April 22, 2021

Subject: The Initial Study of Solar 66 is incomplete without an analysis of cumulative impacts. The project requires an EIR.

Project # 2020-00144/P201800521; APN 0516-001-04, 0516-012-02

Figure 1: Chart of Historical Mojave Floods https://cms.sbcounty.gov/Portals/50/floodcontrol/mojavechartrevised.pdf

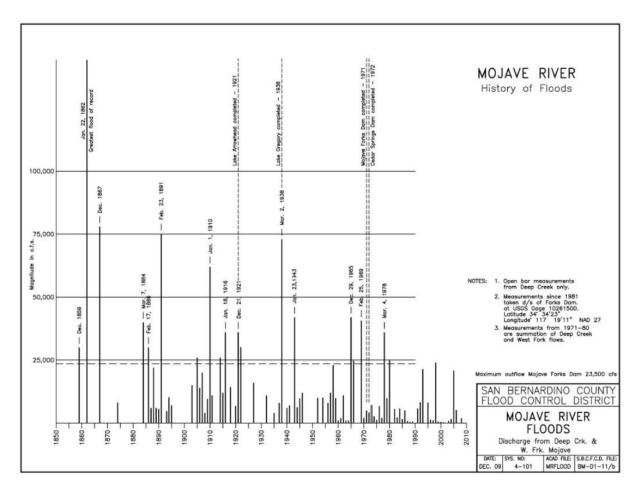
The description of the site states "The Mojave River dry riverbed occupies the northeastern portion of the property." This description is incomplete and should also include the following important change of risk. On November 1, 2019, the Army Corps of Engineers issued a news release announcing the changed Mojave River Dam's risk characterization from low to high urgency.

"The change was the result of recent risk assessment findings that during an extreme flood event, water could exceed the design capacity of the dam and overtop it. This could potentially result in dam failure, flooding the communities of Hesperia, Apple Valley, Victorville, and Barstow, located adjacent to the Mojave River. Floor waters could also reach Baker, more than 140 miles downstream of the dam." Although the river is known to run underground much of its length, hence its common name "the upside-down river" historical records of flooding between 1990 – 2010 show three flood events with a magnitude approaching 25,000 cubic feet per second. There were many higher events during prior decades. (Figure 1) (Bold added)

Figure 9: Soils in the Area of Proposed Solar 66, Daggett CA.

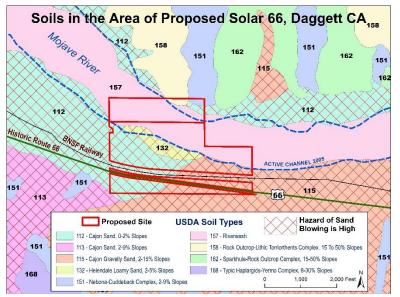
The IS (page 22) gives a grade of "Less Than Significant Impact" because the water erosion on the near surface sandy soils can be mitigated. There is no evaluation for wind erosion. Solar 66 is on the same soil unit as the Stace Project: 112 – Cajon Sand 0-2% Slope. The Natural Resource Conservation Service describes the hazard of water erosion as slight but, **the hazard of soil blowing is high**.² This is no surprise since the area between the I-15 and I-40 east of Barstow, the Lower Mojave River Valley, (LMRV) is basically the outwash plain for the Mojave River sediments.

Soil unit 112 Cajon Sand is also a dominant unit supporting the 3,500-acre Daggett Solar Project

Figure 13: Wildlife linkages LMRV area of the Daggett Projects.

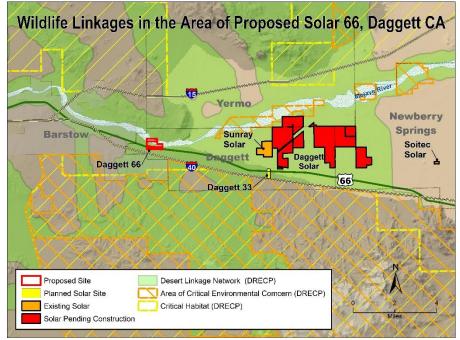
Solar 66 clogs the narrow pass connecting the foothills of Daggett Ridge with Rattlesnake Mountain. Mitigation of this obstruction would take some serious design modifications of the project. Fixed tilt panels and fencing passable for animals was used at Dhamma Vaddhana Vipassana Meditation Center on Mantonya Rd. in

Twentynine Palms. The Daggett Solar project and Sunray take up the space south of the LMRV crossing. There are cumulative wildlife linkages problems to solve here and they are completely overlooked in the IS.

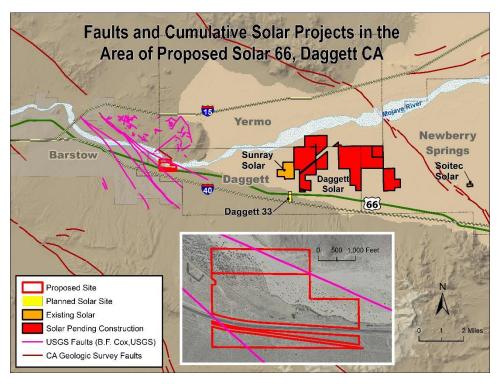
Figure 15: The IS (page 22-23) dismisses the dangers from being located on an "official earthquake fault zone or within a mile of a mapped fault." We urge County Planning to check the accuracy of the Geotechnical Study since it appears in error regarding the mapped USGS and CA Geologic Survey faults.
